BEFORE THE FAST-TRACK EXPERT CONSENTING PANEL

IN THE MATTER	An application for approvals under section 42 of the Fast-track Approvals Act 2024	
AND		
IN THE MATTER	Delmore, a project listed in Schedule 2 to the Fast- track Approvals Act 2024	
MEMORANDUM OF COUNSEL FOR TH	IE APPLICANT RESPONDING TO MINUTE 11	
5 August 2025

Questions in relation to Appendix 45.2 McKenzie &Co. Memo 2/7/25 Transmission Water and Wastewater supply Capacity Assessment

Figure 7 - Average water use per person per day

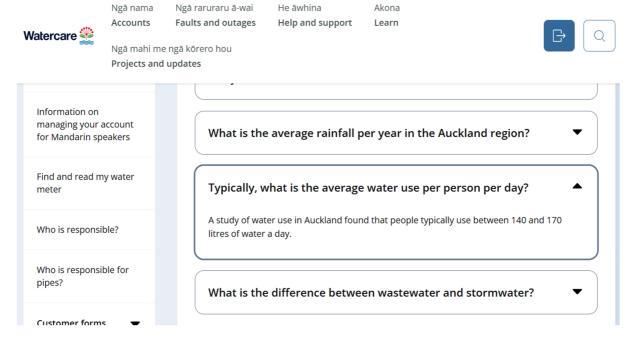
11. Please comment on whether assessment of existing sewer flows and demand has taken into account the large extent of rain tanks on the Whangaparaoa Peninsula- see results of Google search below. Use of rain tanks can result in less water demand and associated wastewater flows compared with that where there is mains water supply.

It is noted that there is a similar layer of conservatism built into the original capacity assessments in Appendix 45.2, and into Scenarios 1 and 2 in the updated capacity assessments in Appendix 1 to this memorandum. We have assumed that all dwellings have a 220 L/p/d per person water demand and corresponding wastewater flow. This aligns with Watercare's standard design Wastewater flow. However, Watercare's data on the actual average water usage per person per day ranges between 140–170 L/p/d which is notably lower than the design usage. To provide and understanding of what is likely to be a more realistic calculation of used and remaining capacity within both networks, we have used 170 L/p/d in Scenario 3 in our updated capacity assessments in Appendix 1 to this memorandum.

We also acknowledge that the widespread use of rainwater tanks on the Whangaparāoa Peninsula may contribute to reduced potable water demand and, by extension, lower wastewater generation for some properties. This dynamic introduces an additional buffer to our wastewater flow estimates, which are otherwise based on conservative assumptions.

It is important to note that while rainwater tanks reduce reliance on the mains water supply, their effect on wastewater generation is less straightforward. Some properties with water tanks may also still be using on-site wastewater systems such as septic tanks. These may remain active even after public wastewater infrastructure becomes available, particularly since septic systems are underground and not always decommissioned. Other properties with water tanks may not use septic tanks.

3725-1-6100

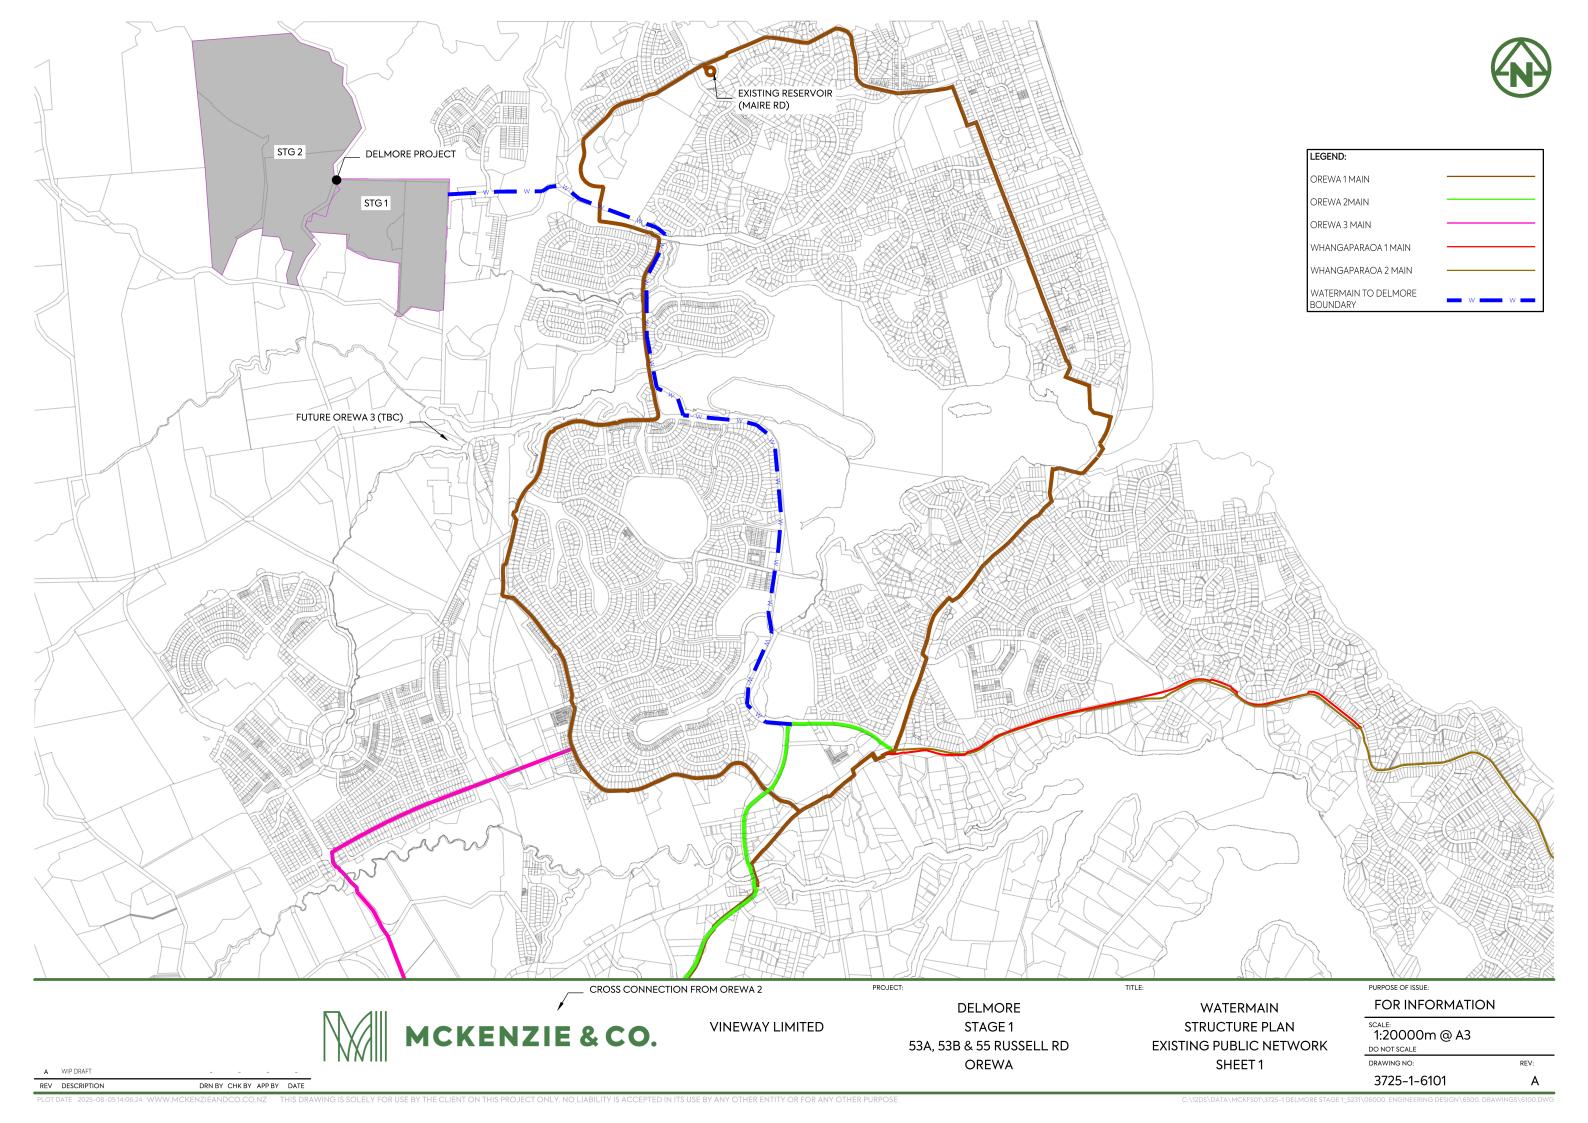
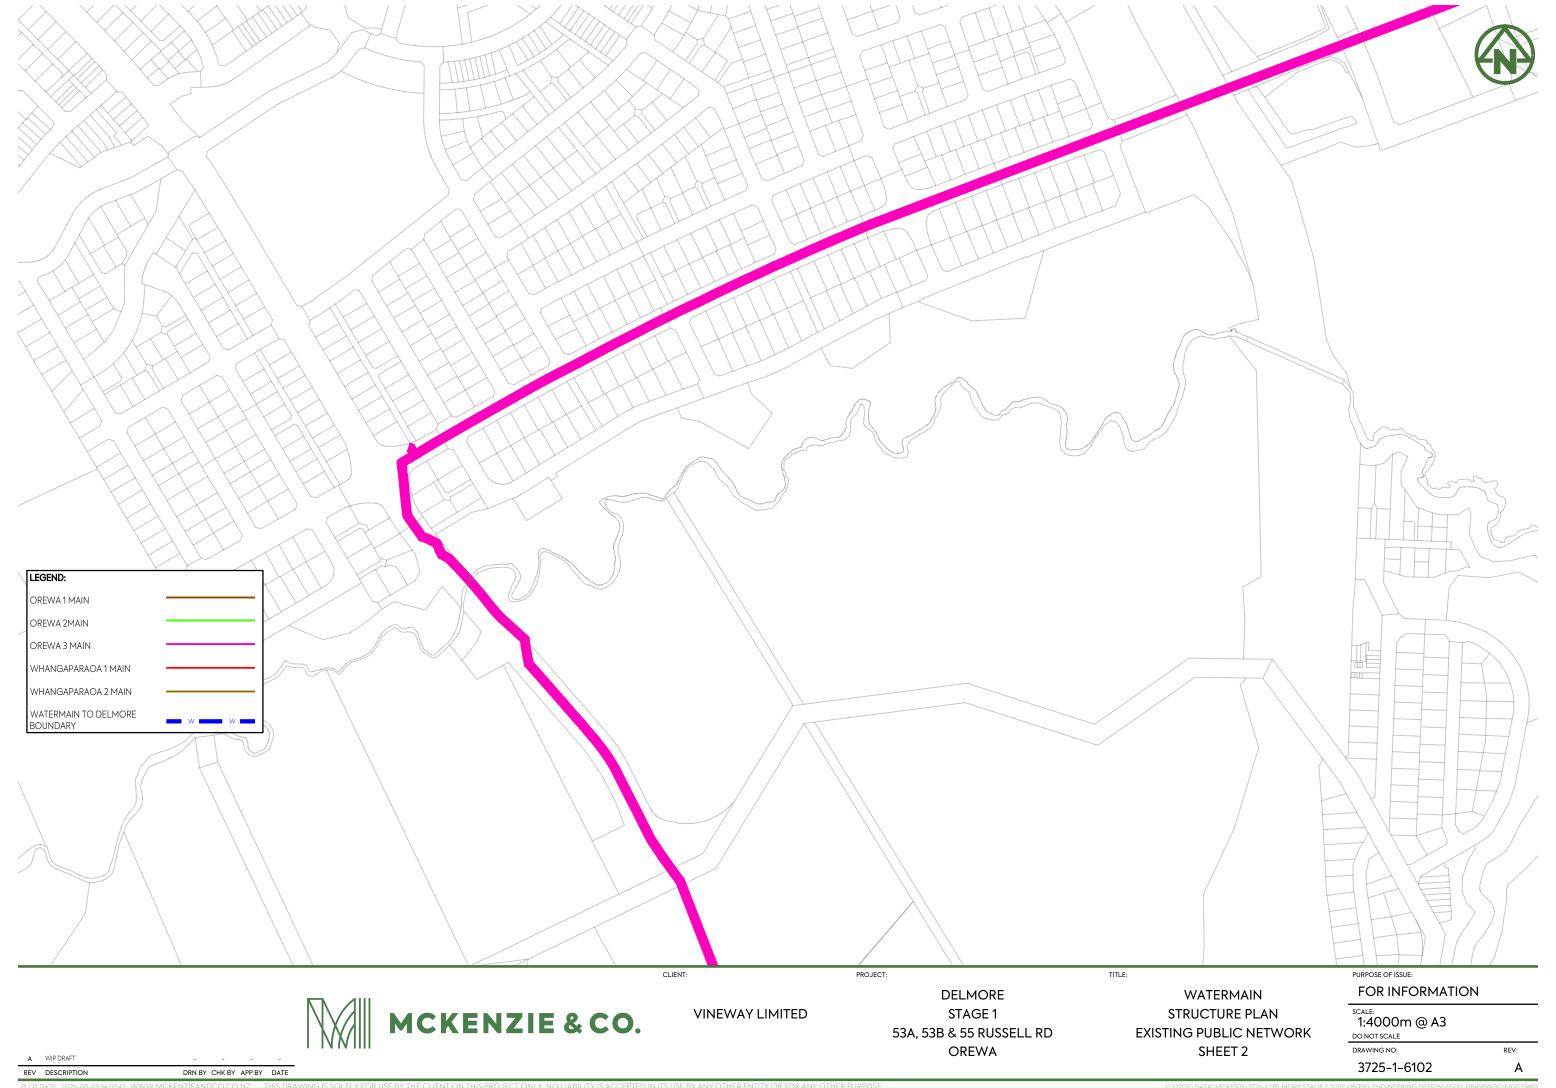
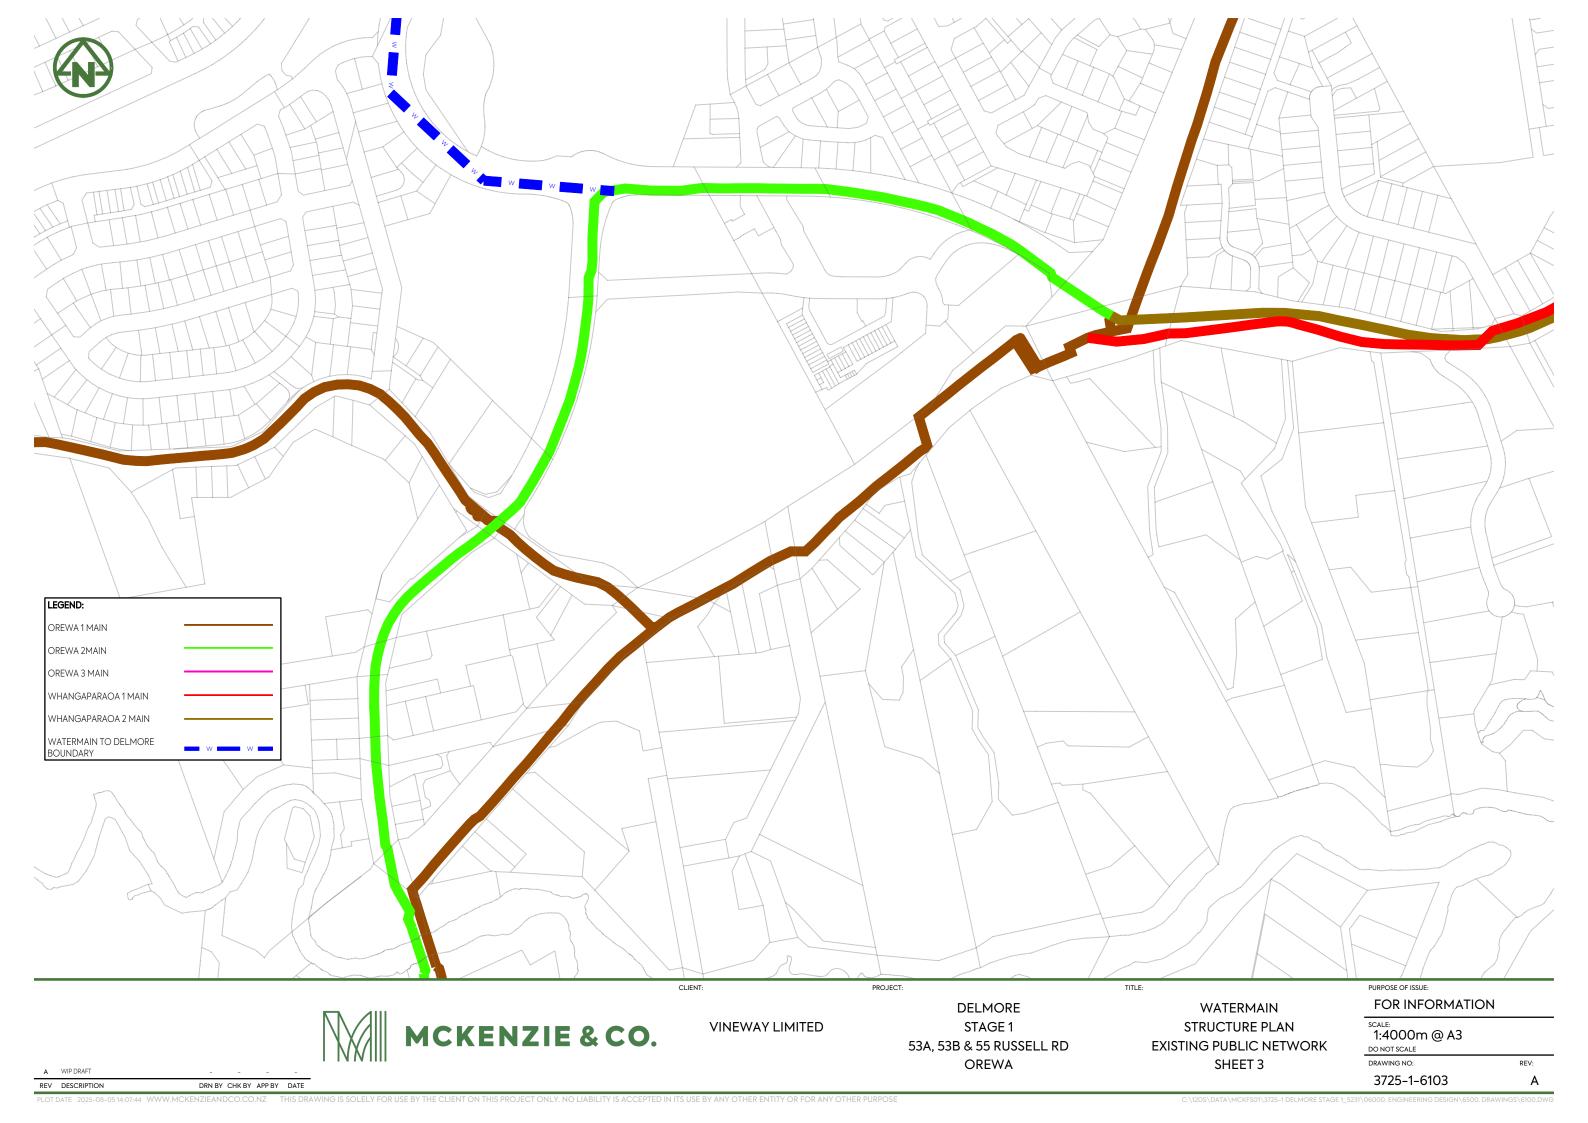
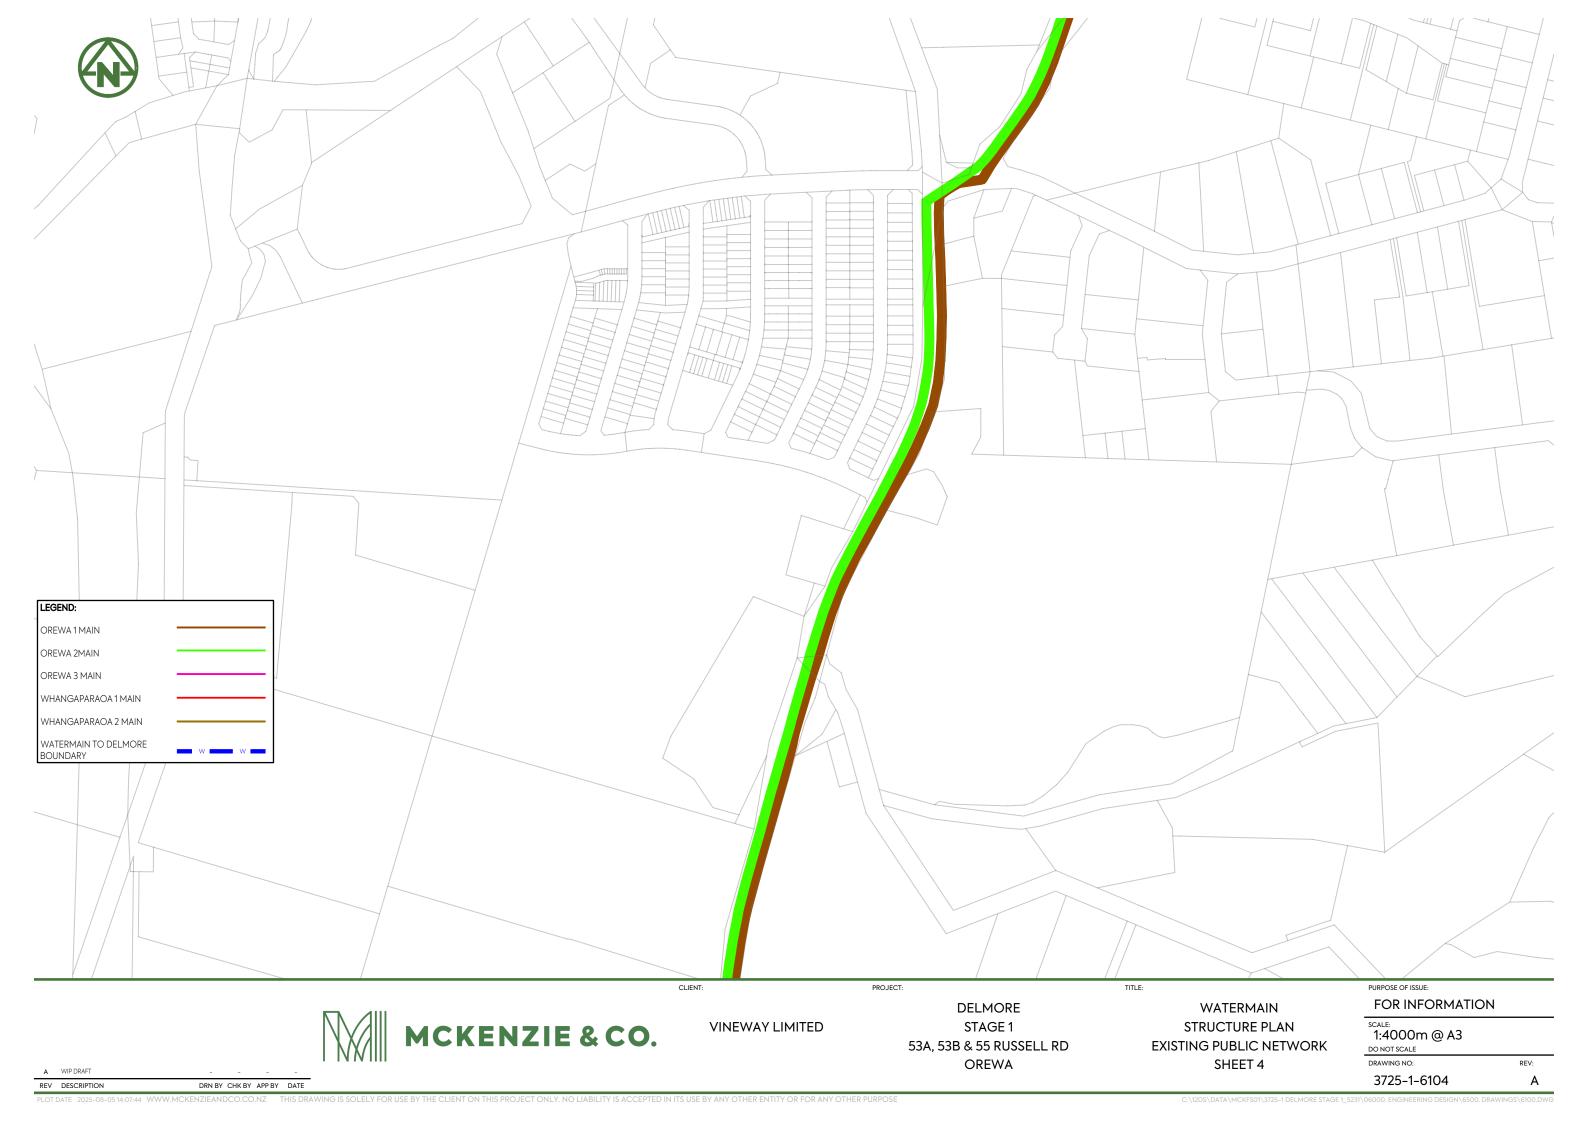
1. Please provide an updated Figure 1 showing Orewa Pipelines 1,2 and 3 in different colours and location of the East Coast Road booster pump.

Updated plans have been prepared and is available for reference under drawing number 3725-S1-6100 to 6104, which illustrates the three Orewa pipelines with individual colour coding for easy identification (see Appendix 2 to this memo). The location of the East Coast Road booster pump station is also depicted—refer to the figures above for visual context
